Access Compliance Report

Public Rights-of-Way

(Curb Ramps)

Intersection ID: 49101	Main Street: PROSPERITY_CROSSING_DR	Cross Street: DOCIA_CROSSING_RD	Location: NW
ADA ID: A560383F1EA8	Ramp Type: Perp	Initial Pass/Fail: Fail	Overall Compliance: No
Severity Score: 26.25			
Codes/Mitigation Info/Possible Solution		Field Measurements/Component Compliance

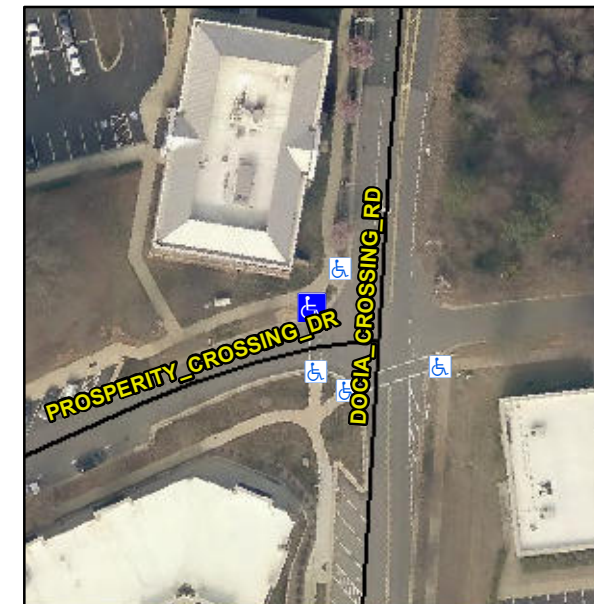
R304.2.2, R304.5.3

Compliance	Description	Data	Compliance	Description	Data
N/A	Ramp Length (in)	84.0	No	Ramp Slope (%)	17.3
Yes	Ramp Width (in)	48.0	No	Ramp XSlope (%)	4.4
N/A	Flare Type LT	N/A	N/A	Flare Type RT	N/A
N/A	Flare Slope LT (%)	N/A	N/A	Flare Slope RT (%)	N/A
N/A	Flare Traversable LT?	N/A	N/A	Flare Traversable RT?	N/A
N/A	Landing Length (in)	N/A	N/A	DWS Provided?	N/A
N/A	Landing Width (in)	N/A	N/A	DWS Contrast?	N/A
N/A	Landing Slope (%)	N/A	N/A	DWS Length (in)	N/A
N/A	Landing X Slope (%)	N/A	N/A	DWS Full Width?	N/A
N/A	Landing Curb? (Y/N)	N/A	N/A	DWS Offset (in)	N/A
N/A	Shared Landing?	N/A			
N/A	Gutter Ponding?	N/A	N/A	Gutter Slope (%)	N/A
N/A	Gutter Lip Ht (in)	N/A	N/A	Gutter X Slope (%)	N/A
N/A	Painted X Walk1?	Yes	N/A	Painted X Walk2?	N/A
	X Walk 1 Direction	To S		X Walk 2 Direction	N/A
N/A	X Walk 1 Width (in)	62.0	N/A	X Walk 2 Width (in)	N/A
	X Walk 1 Slope (%)	4.1		X Walk 2 Slope (%)	N/A
	X Walk 1 X Slope (%)	4.7		X Walk 2 X Slope (%)	N/A

Remove & Replace Entire Ramp.
